ROADWAY P&P

GRADING & EROSION CONTROL PLANS
GRANDVIEW RESERVE FILING NO. 1
4 SITE INVESTMENTS, LLC (D.R. HORTON)
SF-22-XXX **SF2311**

STORM DRAIN DETAILS

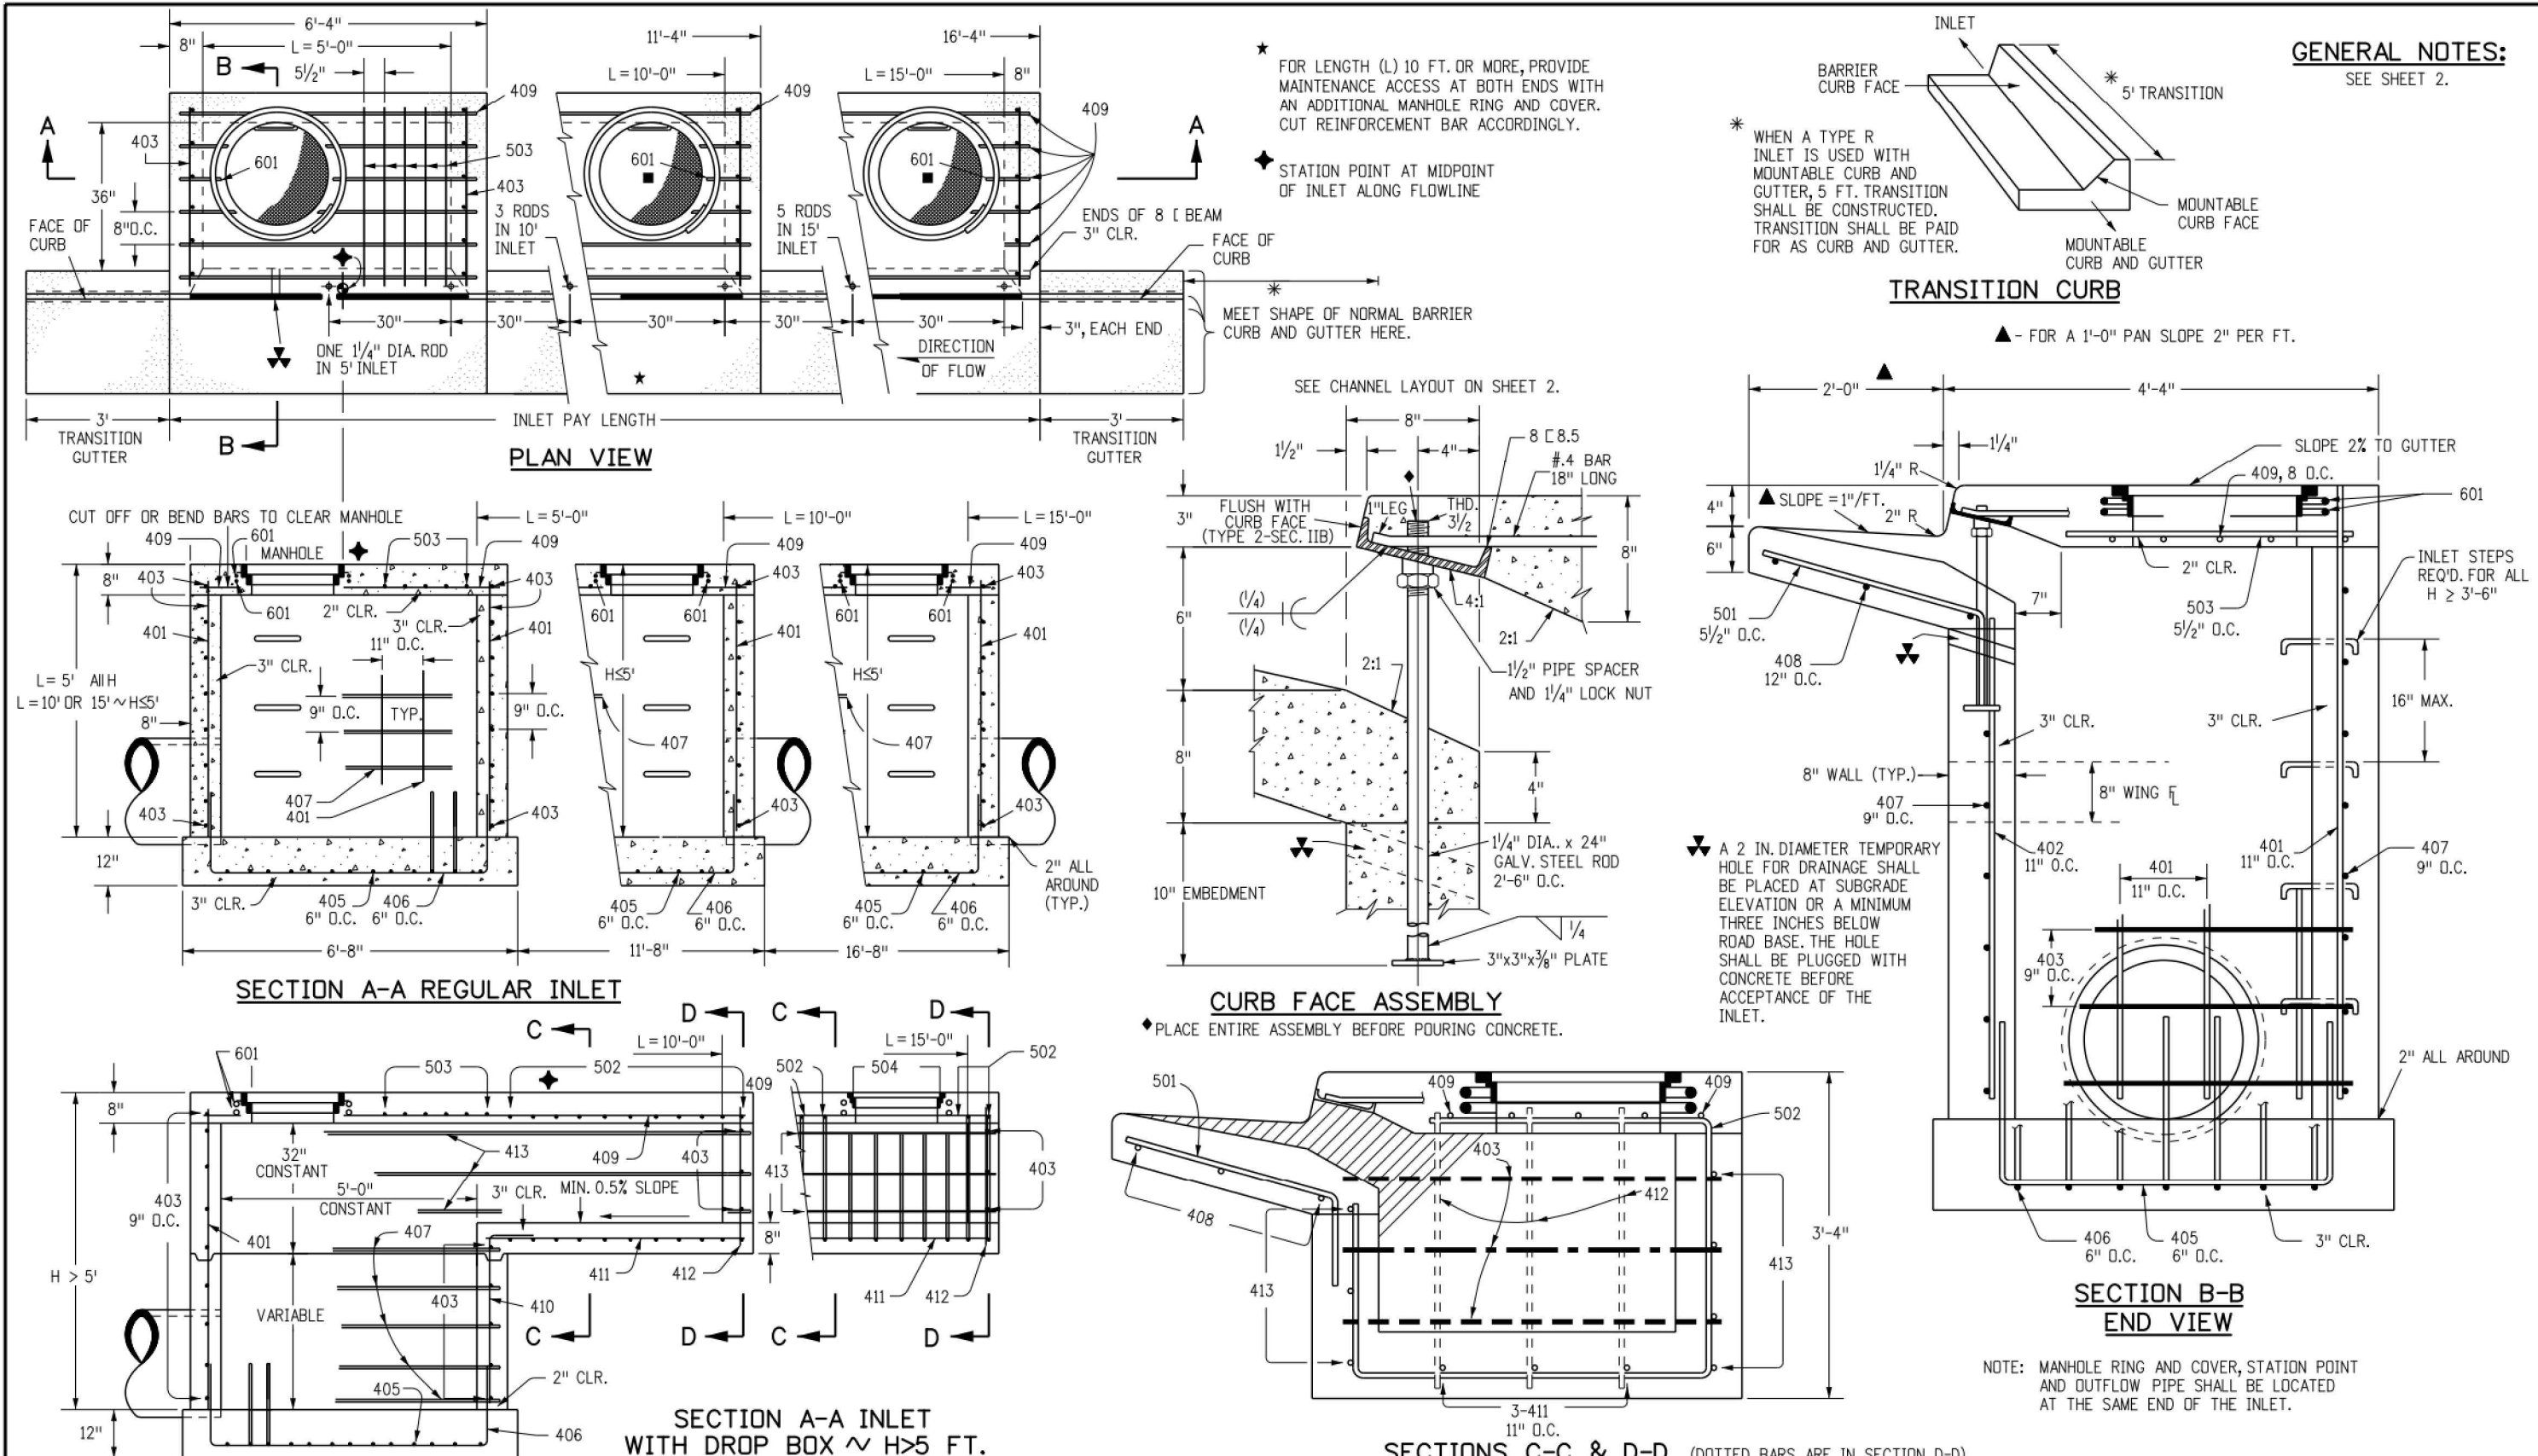
Include ECM Detail SD_3-5
